Access Compliance Report

Public Rights-of-Way

Intersection ID: 47692	Main Street: AMBER_MEADOWS_DR	Cross Street: GLENOLDEN_DR	Location: E
ADA ID: C9781DAFAD40	Ramp Type: Perp	Initial Pass/Fail: Fail	Overall Compliance: No
Severity Score: 33.75			
Codes/Mitigation Info/Possible Solution		Field Measurements/Component Compliance

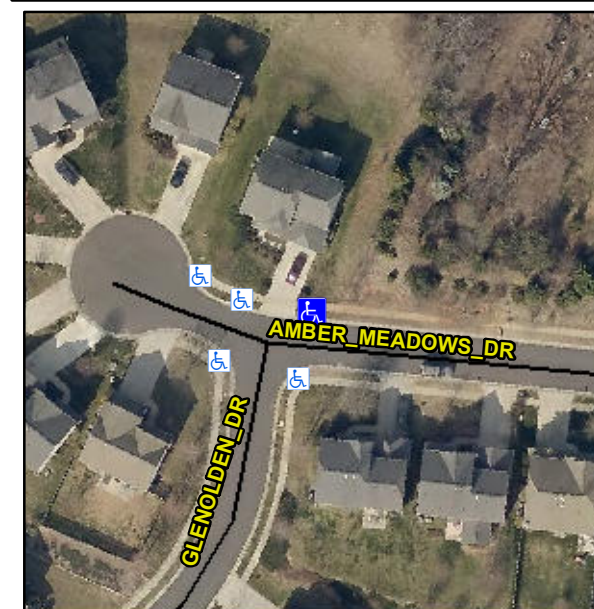
Not Found, R304.5.1, R304.2.2

Compliance	Description	Data	Compliance	Description	Data
N/A	Ramp Length (in)	48.0	No	Ramp Slope (%)	13.5
No	Ramp Width (in)	47.0	Yes	Ramp XSlope (%)	1.3
N/A	Flare Type LT	N/A	N/A	Flare Type RT	N/A
N/A	Flare Slope LT (%)	N/A	N/A	Flare Slope RT (%)	N/A
N/A	Flare Traversable LT?	N/A	N/A	Flare Traversable RT?	N/A
N/A	Landing Length (in)	N/A	N/A	DWS Provided?	N/A
N/A	Landing Width (in)	N/A	N/A	DWS Contrast?	N/A
N/A	Landing Slope (%)	N/A	N/A	DWS Length (in)	N/A
N/A	Landing X Slope (%)	N/A	N/A	DWS Full Width?	N/A
N/A	Landing Curb? (Y/N)	N/A	N/A	DWS Offset (in)	N/A
N/A	Shared Landing?	N/A			
N/A	Gutter Ponding?	N/A	N/A	Gutter Slope (%)	N/A
N/A	Gutter Lip Ht (in)	N/A	N/A	Gutter X Slope (%)	N/A
N/A	Painted X Walk1?	No	N/A	Painted X Walk2?	N/A
	X Walk 1 Direction	To S		X Walk 2 Direction	N/A
N/A	X Walk 1 Width (in)	N/A	N/A	X Walk 2 Width (in)	N/A
	X Walk 1 Slope (%)	1.6		X Walk 2 Slope (%)	N/A
	X Walk 1 X Slope (%)	2.8		X Walk 2 X Slope (%)	N/A

Remove & Replace Entire Ramp.
